ADDENDUM NO.: THREE

DATE OF ADDENDUM: January 12, 2016

**NEW MANUFACTURING TECHNOLOGY CENTER
ASNUNTUCK COMMUNITY COLLEGE
170 ELM STREET
ENFIELD, CT
BI-CTC-488**

SKETCH TITLE SAMPLE PANEL

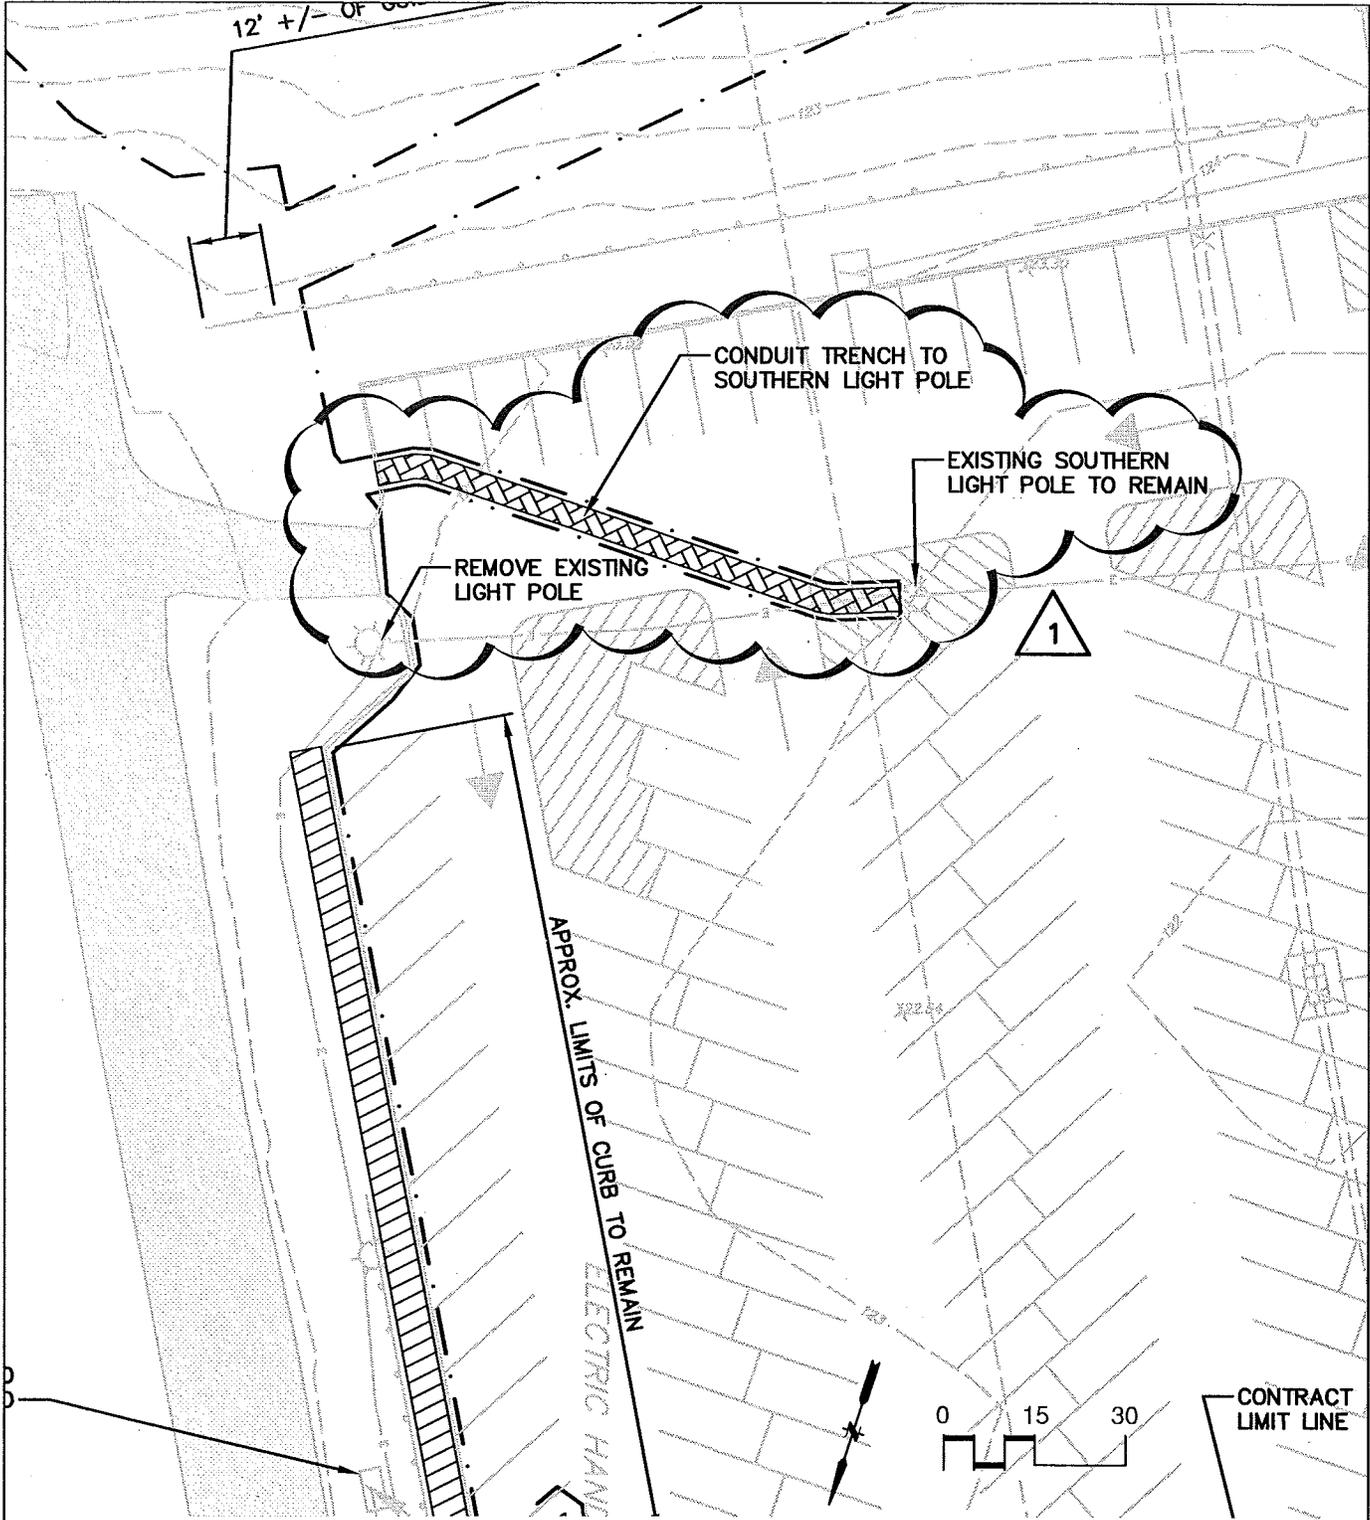
REVISE as shown by sketch AD3-SK-INFO.1 entitled SAMPLE PANEL dated 1/11/2016 attached to and issued with this Addendum.

1. CONSTRUCT SAMPLE WALL PANEL PER CONSTRUCTION DOCUMENTS, WITH 12" PRECAST INSULATED ARCH. PANEL WITH GRANITE FACE, PREFINISHED ALUMIN. CURTAIN WALL, OPERABLE VENTS, SUNSCREEN, ZINC COMPOSITE PANEL, ZINC PANEL SUN SHADE, ZINC COMPOSITE PANELS ON MTL FURRING AND ZINC COPING.
2. RETURN ALL FINISHES 12" AT CORNER, ONE END
3. SAMPLE PANEL CONSTRUCTION SHALL BE ENTRIELY SELF SUPPORTING PER OSHA REQUIREMENTS WITH OUT EXTERNAL BRACING.
4. LOCATION OF SAMPLE PANEL SHALL BE CORRORDINATED W/ARCH.

SKETCH TITLE REVISED LIGHTING POLE TO BE

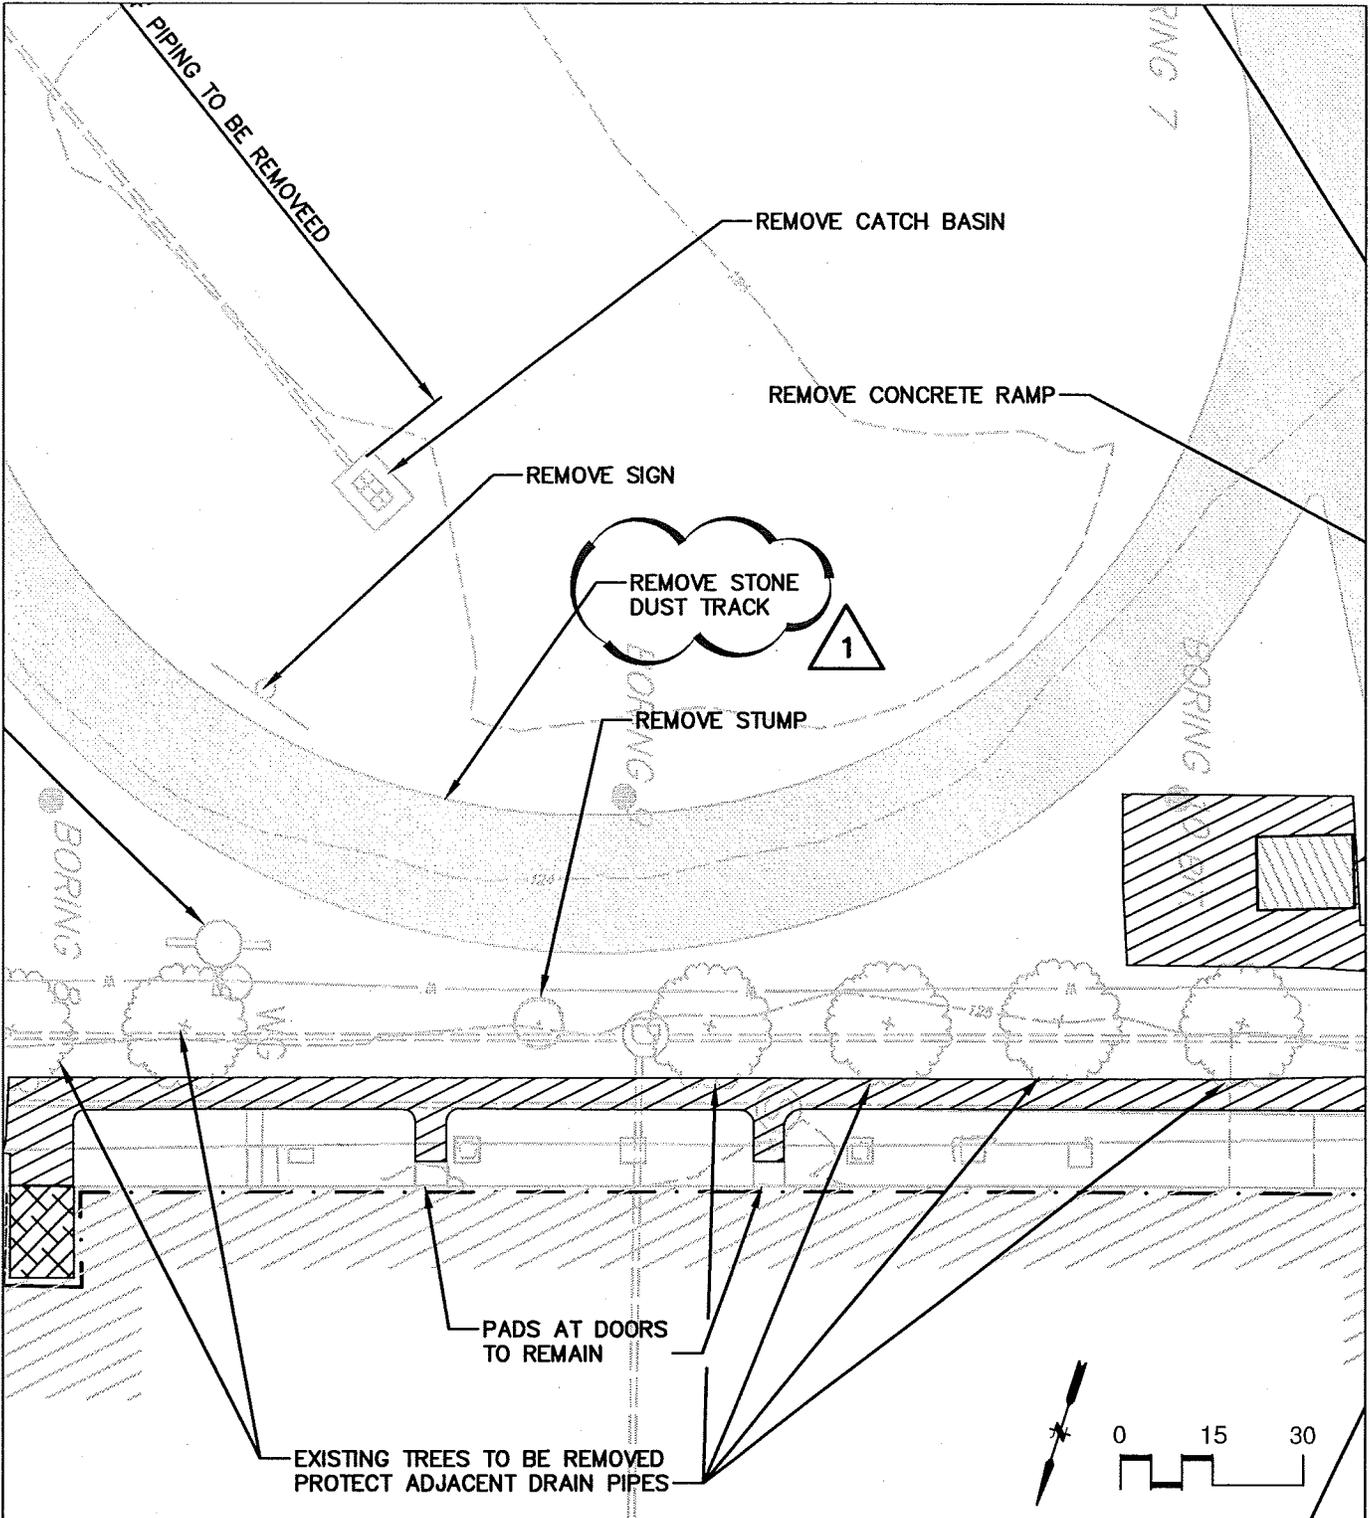
DRAWING CP-101 – SITE PREPARATION PLAN: **REVISE** plan to show correct existing southern light pole to be reused and add trench for new connecting conduit as shown by attached sketch AD3-SK-CP-101-1 titled "REVISED LIGHTING POLE TO BE REUSED AND CONDUIT TRENCH".

SKETCH TITLE REVISED STONE DUST TRACK REMOVAL

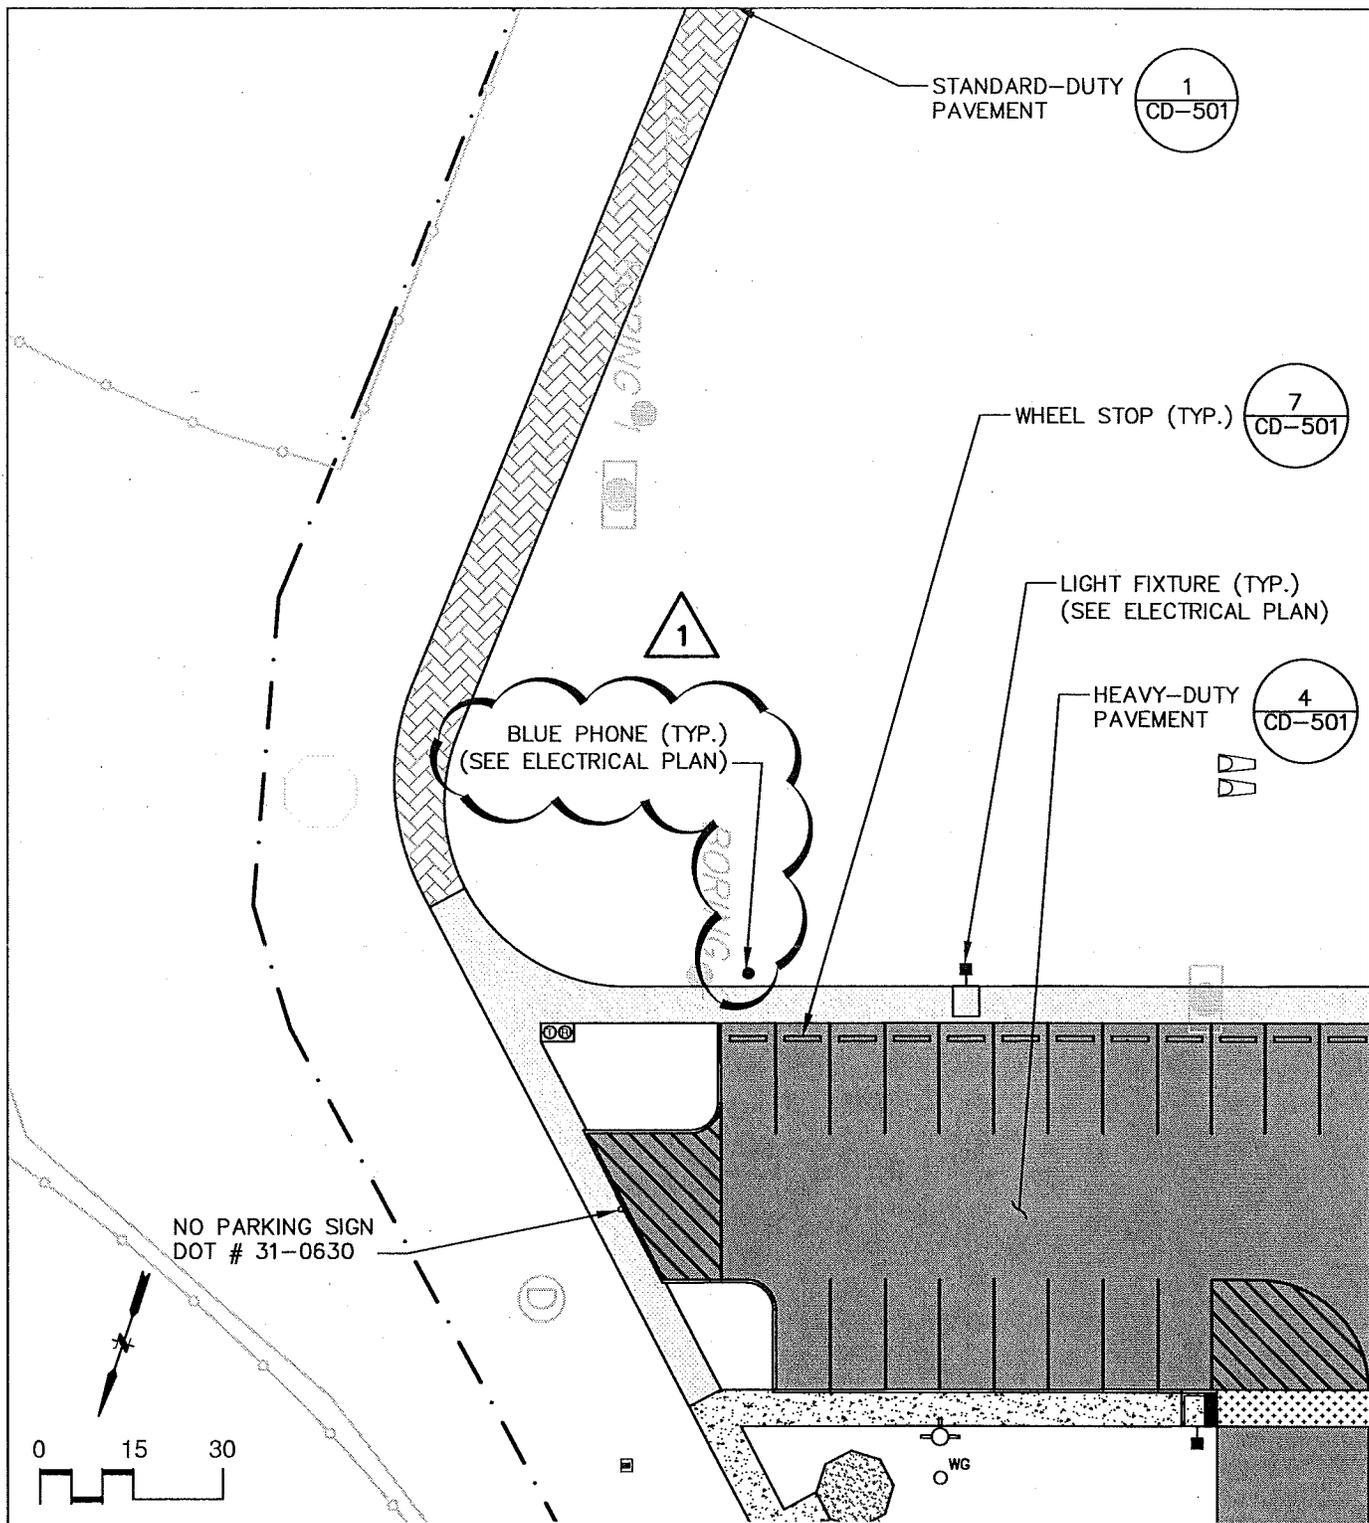
DRAWING CP-101 – SITE PREPARATION PLAN: **REVISE** plan to require removal of the existing stone dust track material as shown by attached sketch AD3-SK-CP-101-2 titled "REVISED STONE DUST TRACK REMOVAL".

SKETCH TITLE REVISED ACCESSIBLE PARKING SPACES

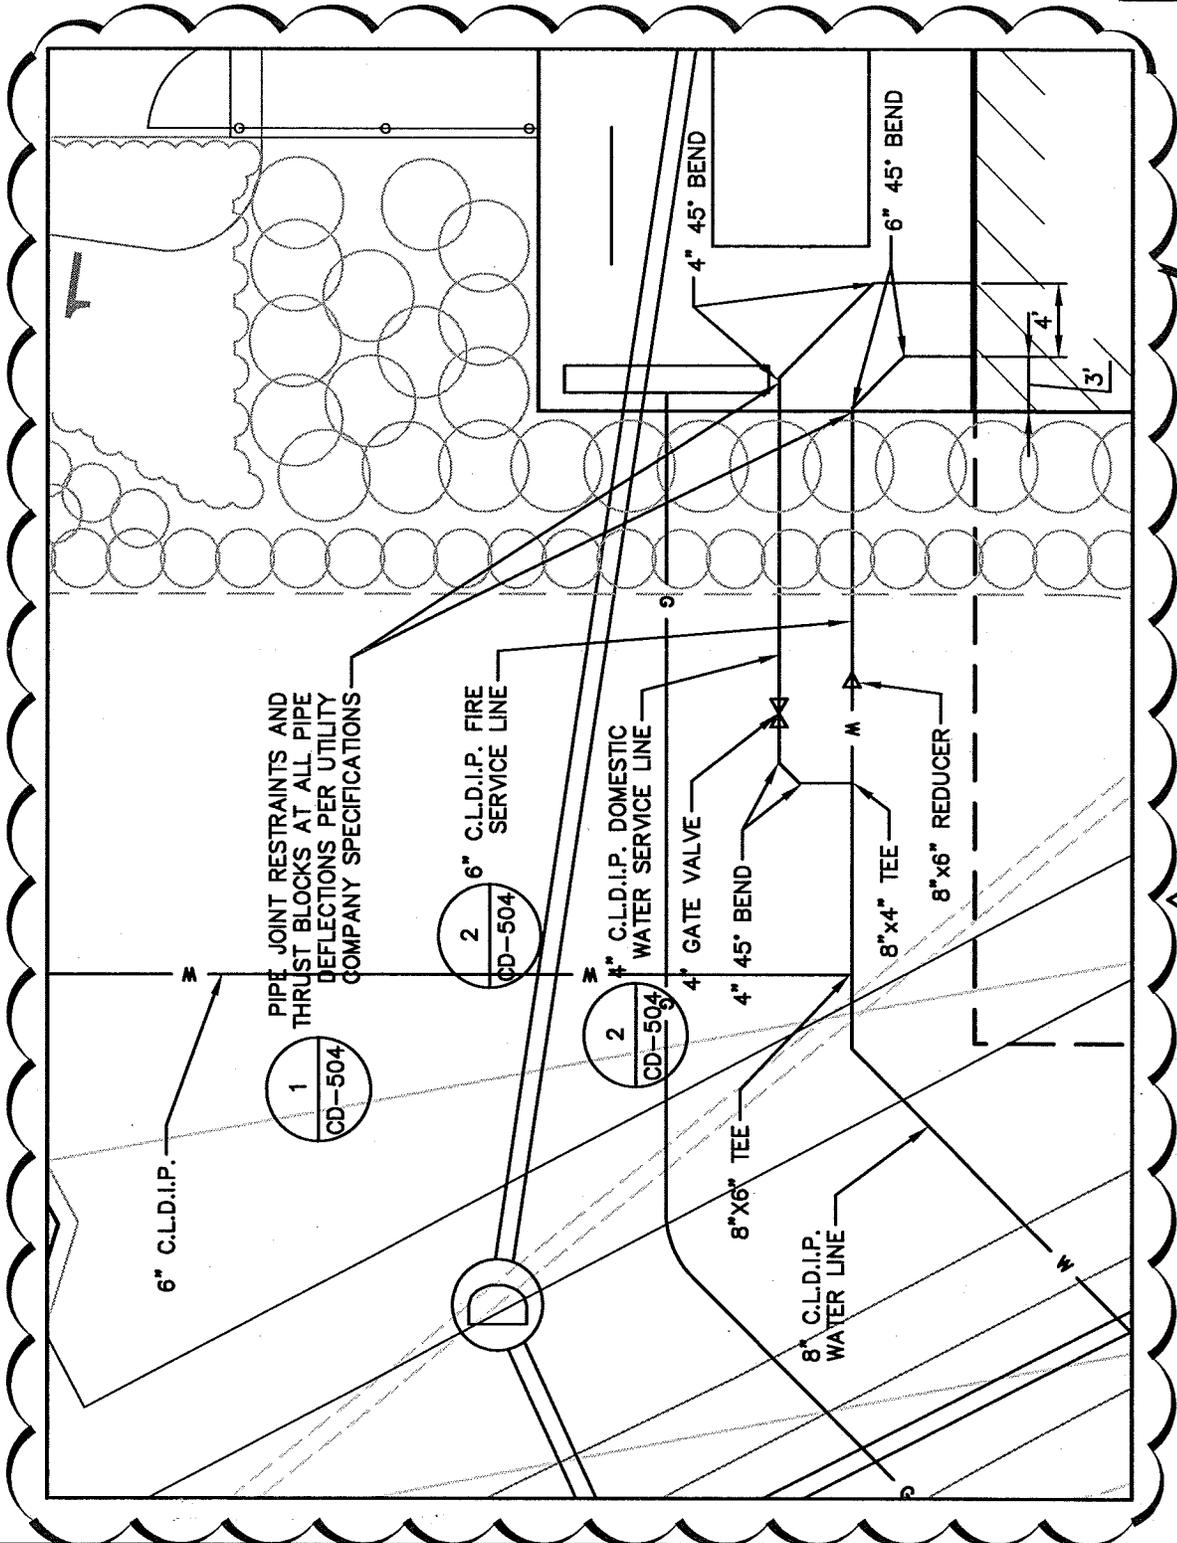
DRAWING CS-101 – SITE PAVEMENT AND SIGNAGE PLAN: **REVISE** plan to show correct location of accessible parking spaces as shown by attached sketch AD3-SK-CS-101-2 titled "REVISED ACCESSIBLE PARKING SPACES".

SKETCH TITLE RELOCATED HC PARKING SPACES

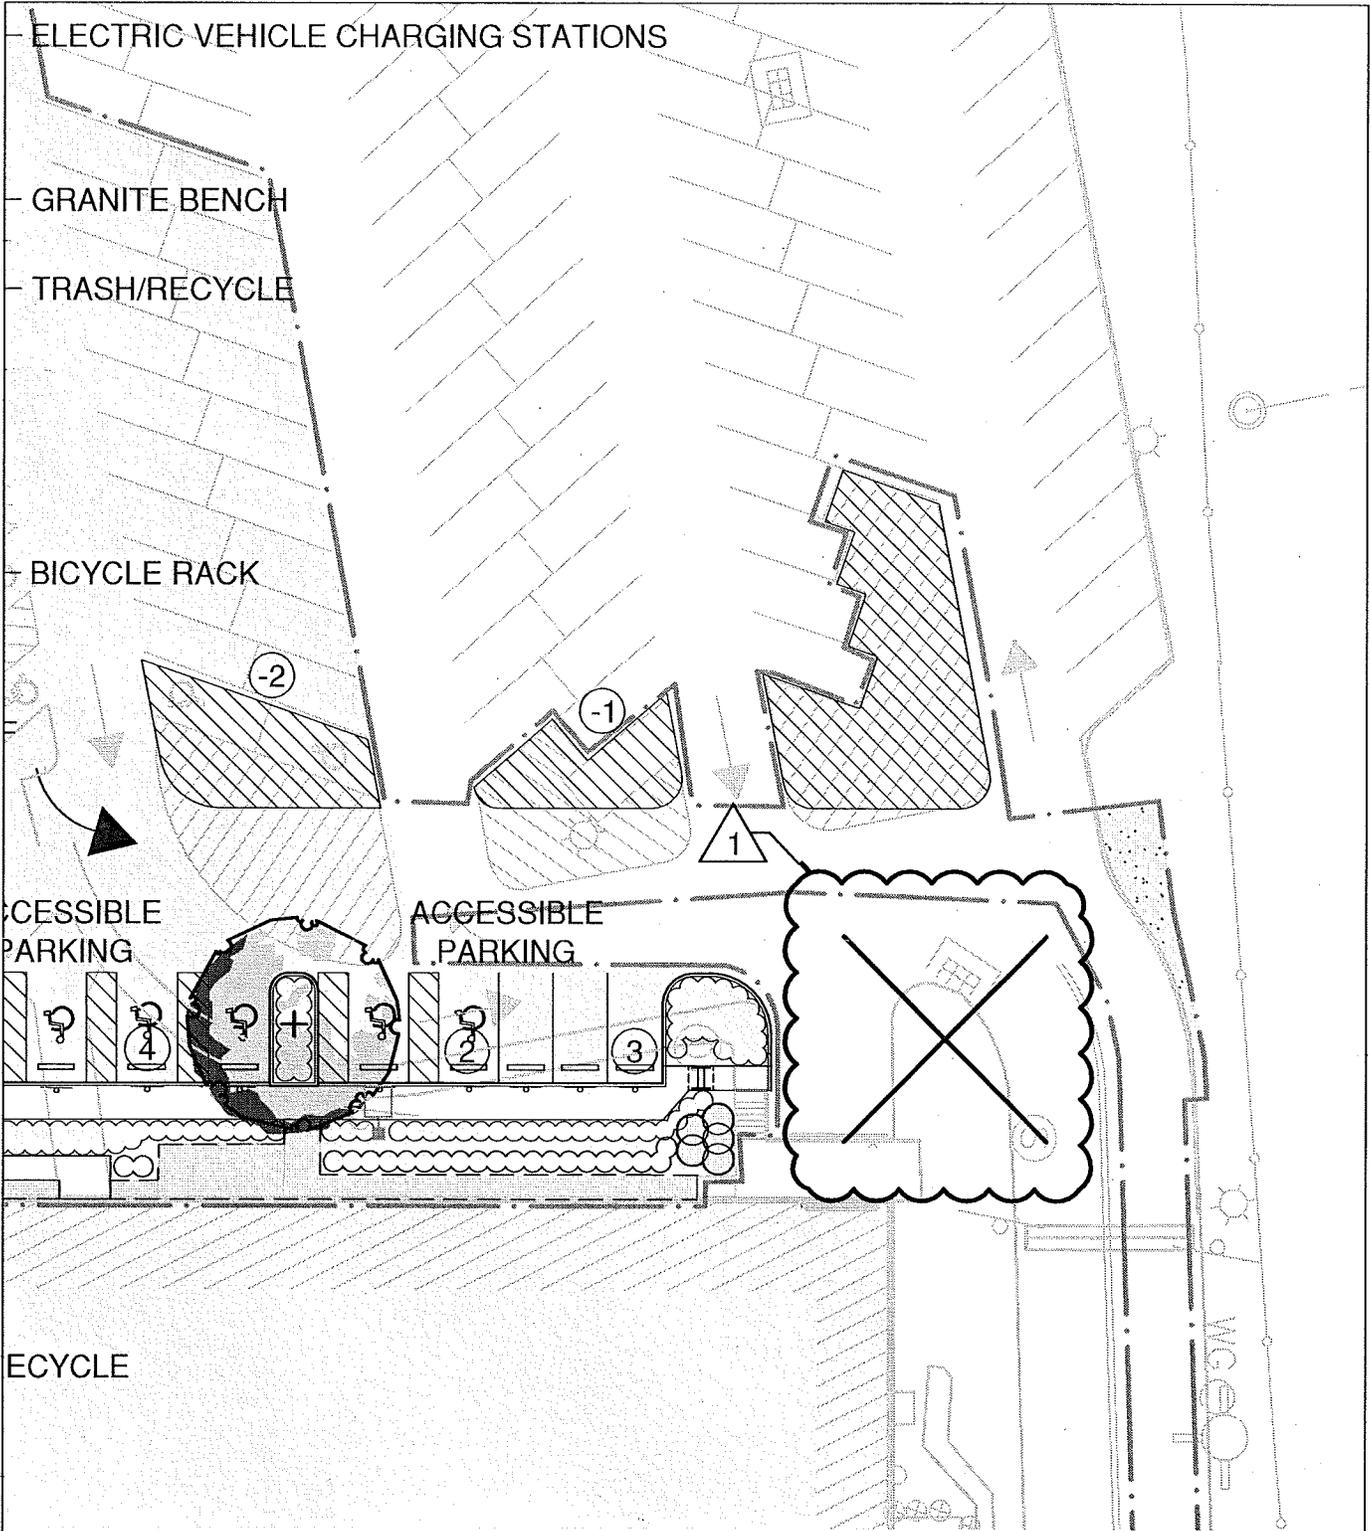
DRAWING L1.0 – SITE ILLUSTRATIVE PLAN: REVISE plan to relocate two (2) HC Accessible Parking Spaces as shown by attached sketch AD3-SK-L1.0-1 titled "RELOCATED HC PARKING SPACES" dated 01/11/2016.
